UCRL-AR-126418

**Action Memorandum for the Pit 6 Landfill  
Operable Unit Removal Action at  
Lawrence Livermore National Laboratory  
Site 300**

SUBJECT: Request for a Removal Action at the Lawrence Livermore National Laboratory (LLNL)  
Site 300 Pit 6 Landfill Operable Unit (OU)

Figure 5. Ground water monitor well locations.

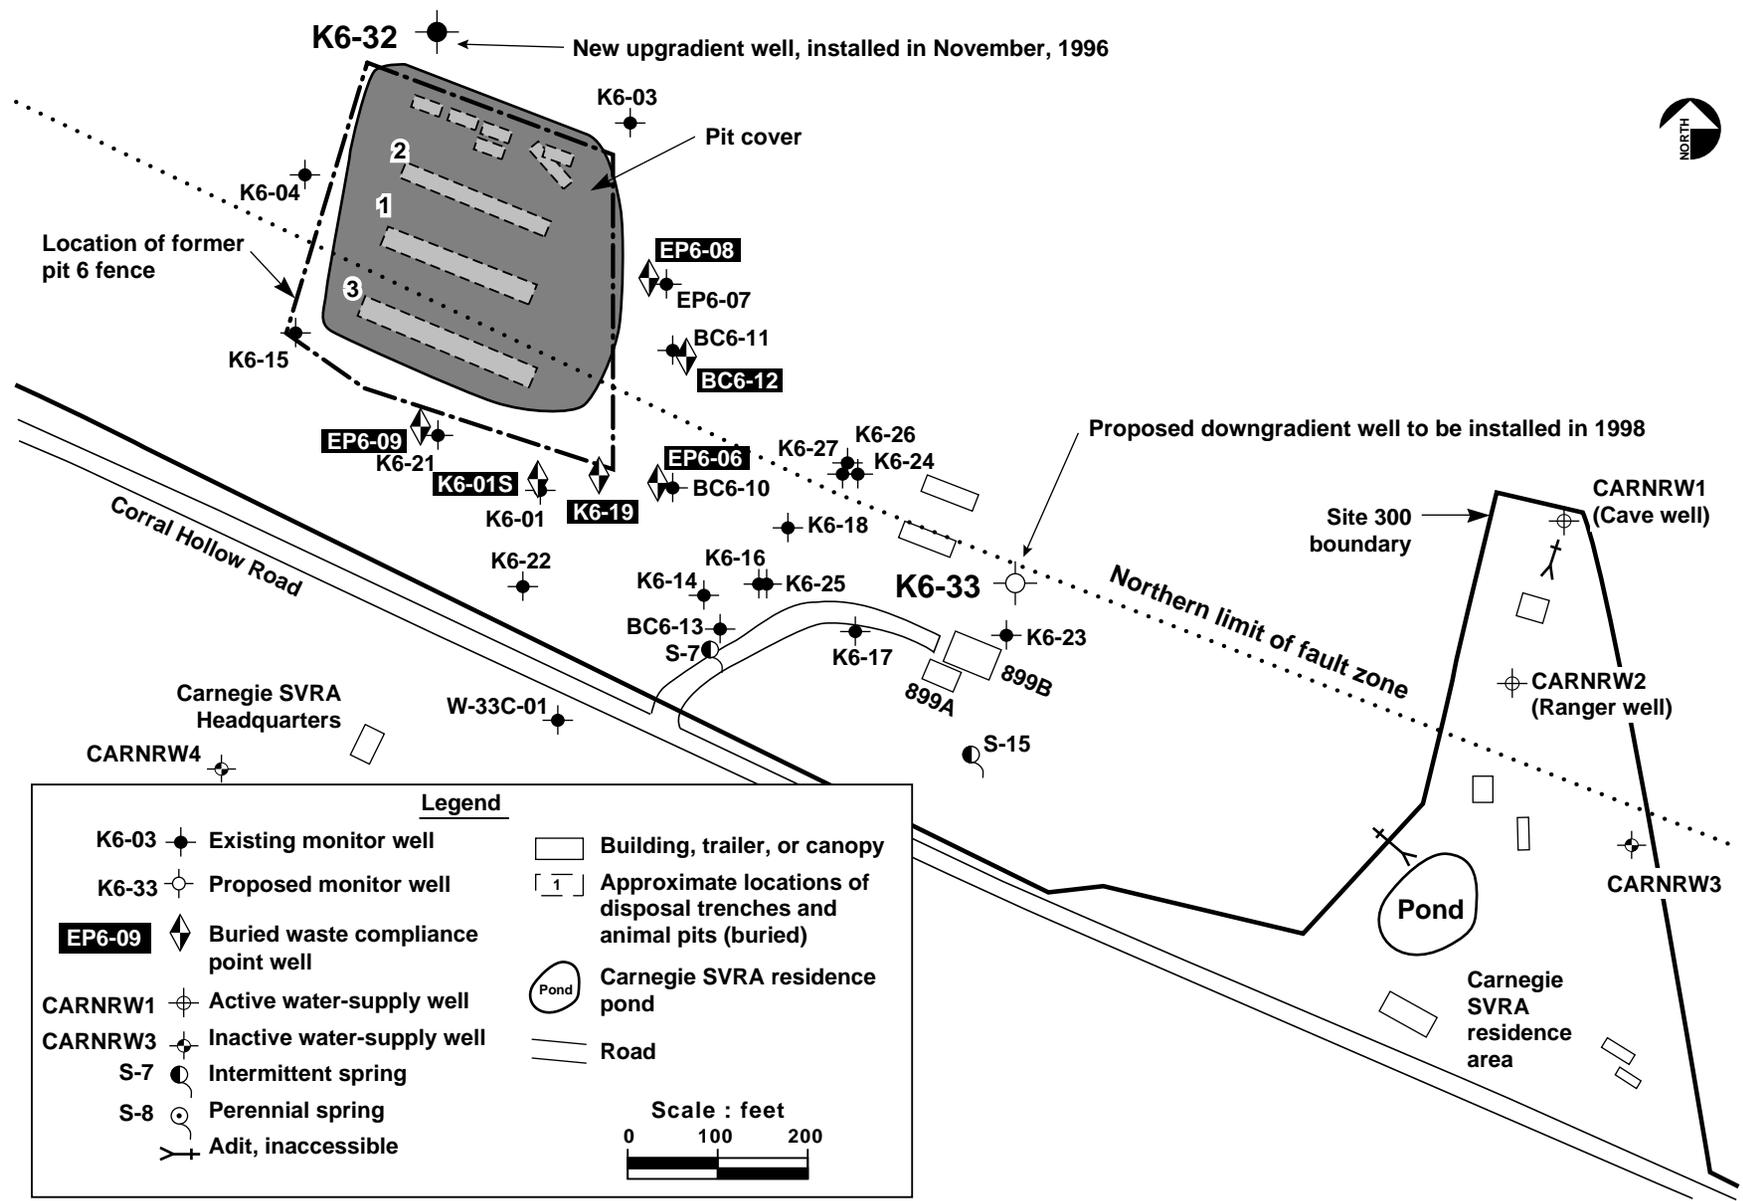
*Regarding the monitoring plan for Pit 6, we think it needs to be articulated prior to acceptance of the EE/CA. We would like to see the location and number of wells being proposed, the frequency of monitoring, and what constituents will be sampled. We would also like you to explain how LLNL proposes to prove or disprove the occurrence and rate of natural attenuation.*

A ground water monitoring plan is presented as Table 2 of the EE/CA Addendum. Monitor well locations and function are also shown in the same document on Figure 7. A Post-Closure Plan will be prepared and issued upon completion of the landfill cover (December 1, 1997), which will detail monitoring plans for detecting potential future releases from the landfill and to track the existing VOC plume. Procedures to be used for evaluating the monitoring data will include statistical analysis of sampling data to determine if conditions have changed.
